UNITED STATES PATENT AND TRADEMARK OFFICE

APPLICATION NO.	FILING DATE	FIRST NAMED INVENTOR	ATTORNEY DOCKET NO.	CONFIRMATION NO.
10/720,652	11/24/2003	Seong-Yong Hwang	21C-0098	4656
23413	7590	05/09/2006	EXAMINER	
CANTOR COLBURN, LLP 55 GRIFFIN ROAD SOUTH BLOOMFIELD, CT 06002			CHOWDHURY, TARIFUR RASHID	
			ART UNIT	PAPER NUMBER
			2871

Office Action Summary

DETAILED ACTION

Fig. 2

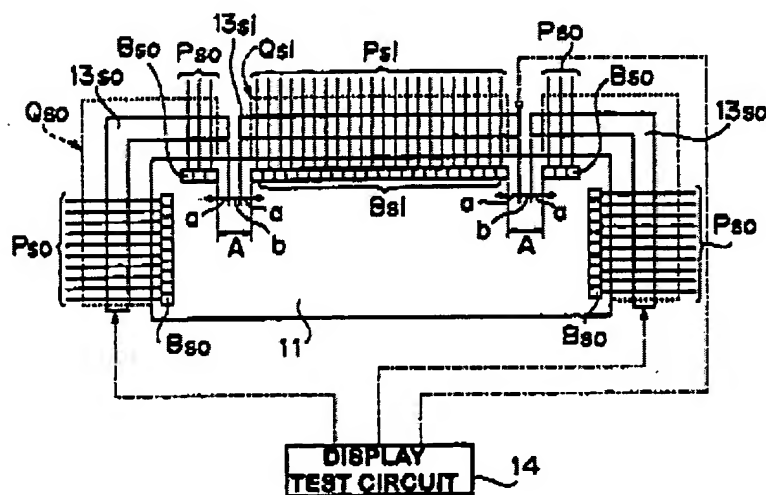
6. Shibatani discloses (col. 7, line 57 – col. 8, line 11) and shows in Fig. 2, a circuit device comprising:

- electrode terminals linearly aligned in a plurality of columns along a first direction parallel to an edge line of a semiconductor substrate (11) and linearly aligned in a plurality of rows along a second direction perpendicular to the first direction and bumps disposed on the electrode terminal (col. 7, lines 57-65),

wherein distances between adjacent two electrode terminals aligned in the first direction are uniform as well as distances between the adjacent two electrode terminals aligned in the second direction are uniform (col. 7, line 66 – col. 8, line 11).

Accordingly, claim 1 is anticipated.

As to claim 3, it is clear from Fig. 2 of Shibatani that each of the bumps (Bsi, Bso) has a rectangular shape when viewed from an upper side of the bumps.
